**REMARKS****INTRODUCTION:**

**OBJECTIONS TO THE DRAWINGS:**

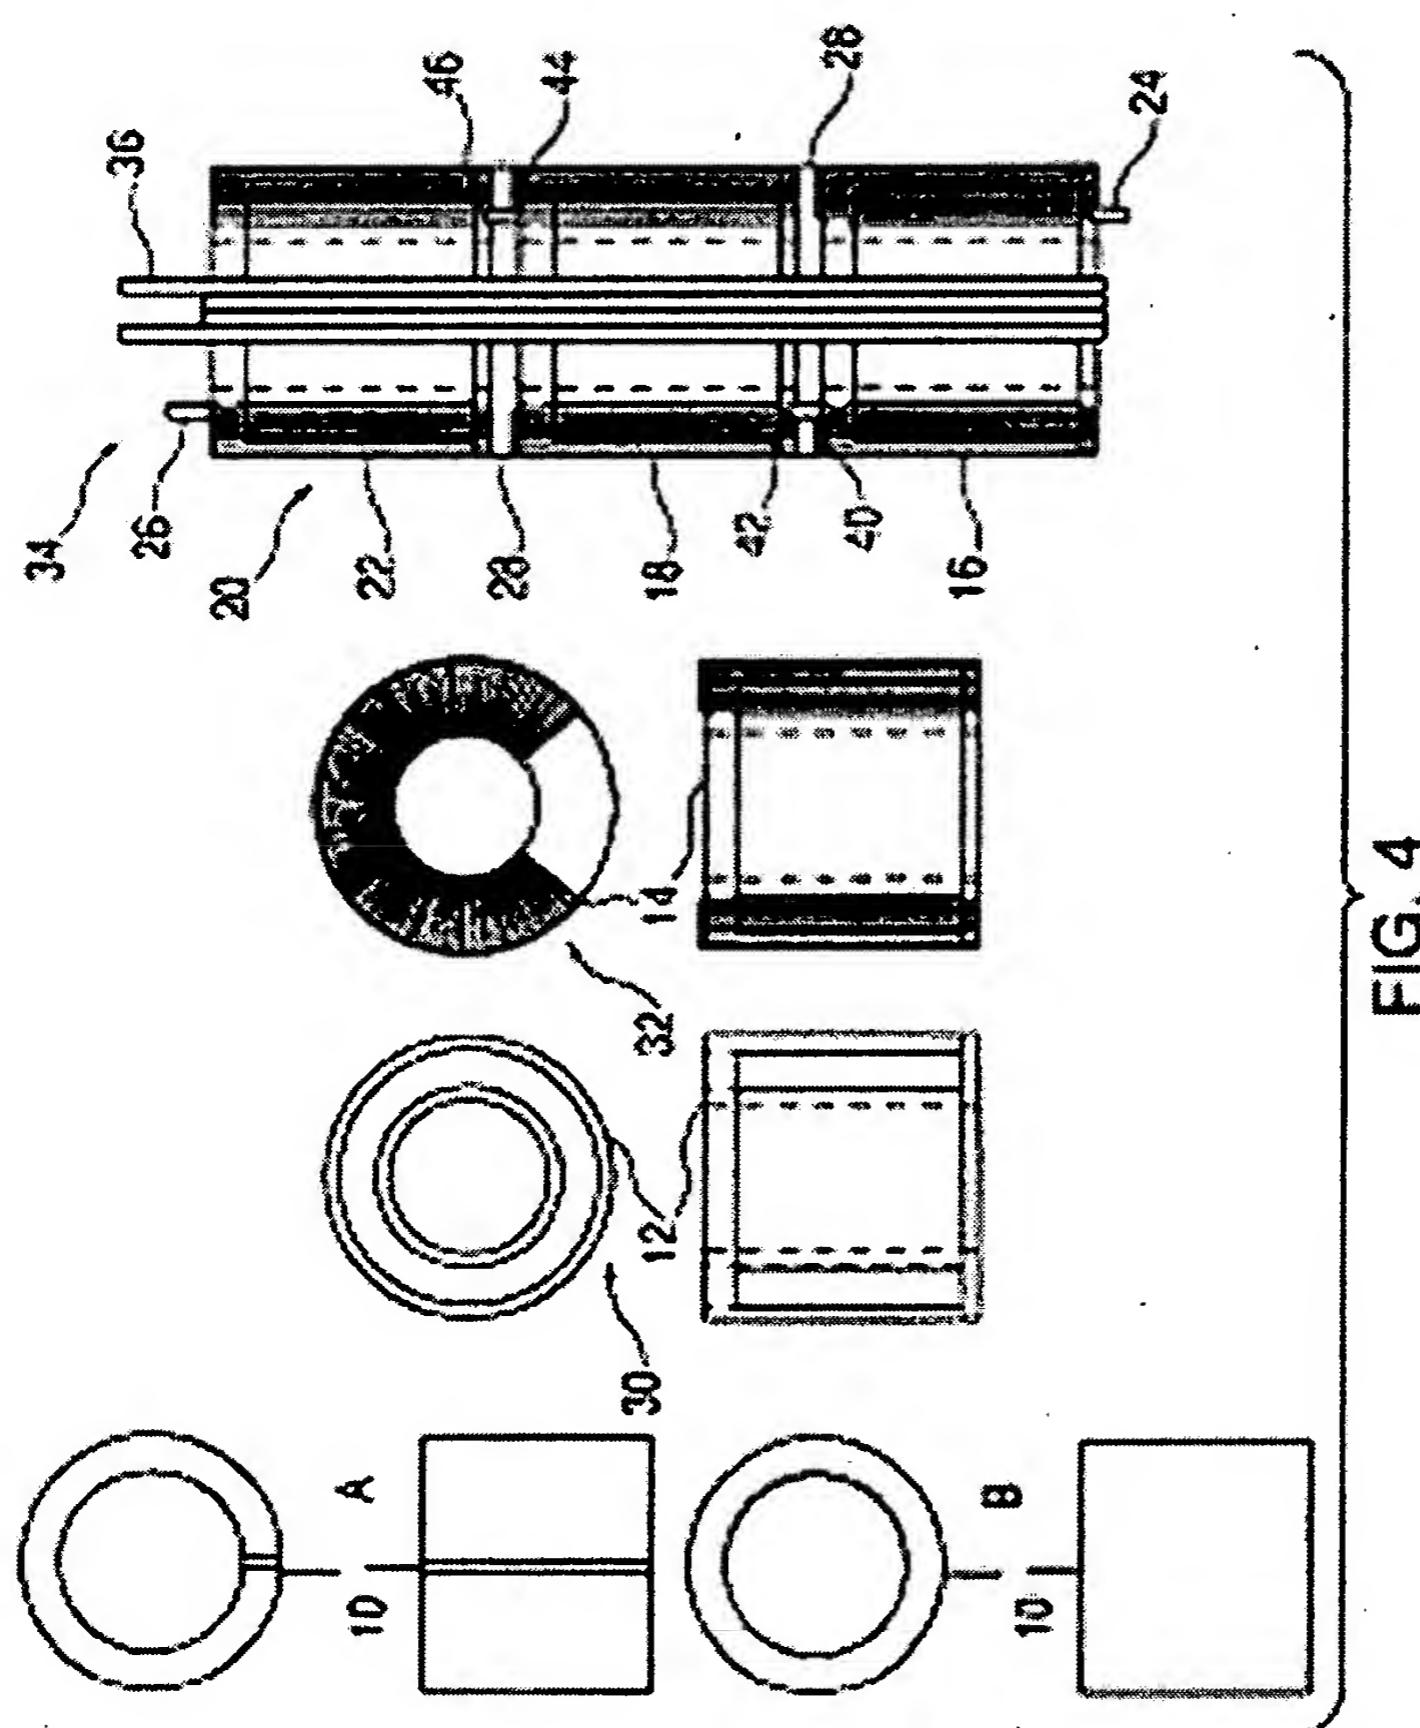
In the Office Action, at page 2, the drawings were objected to. FIG. 9 has been amended to show the non-gapped core 71 more clearly in blow-up form, and a replacement FIG. 9 has been submitted herewith. Therefore, the outstanding drawing objections should be resolved.

FIG. 9 clearly shows non-gapped cores on the substrate plates. It is respectfully submitted that a non-gapped core is known to one skilled in the art. For further clarity, a blow-up of the core is also shown, and for even further clarity, the non-gapped core is labeled "NON-GAPPED CORE." The enlarged core configuration of a non-gapped core in amended FIG. 9 should clarify the type of core which is a "non-gapped core."

In the Office Action, on page 2, the Examiner objected to the drawings. In order to overcome these objections, a replacement figure for FIG. 9 is submitted herewith. In FIG. 9, a blow-up of element 71 is shown, to clarify that the core 71 is non-gapped. Approval of these changes to the Drawings is respectfully requested.

Referring to FigFIG. 9, it is shown that the reproducibility and uniformity for a given permeability value are obtained when a temperature variation of less than one or two degrees is maintained. Special loading configurations have been developed for the annealing process so that the uniformity and reproducibility of the temperature in the oven are established. For a box type inert gas oven, wire mesh A1 plates 72 are stacked according to FIG. 9 and the arrangement is placed in the center of the oven. The A! plates 72 are substrates that hold the non-gapped cores 71 during the anneal process.
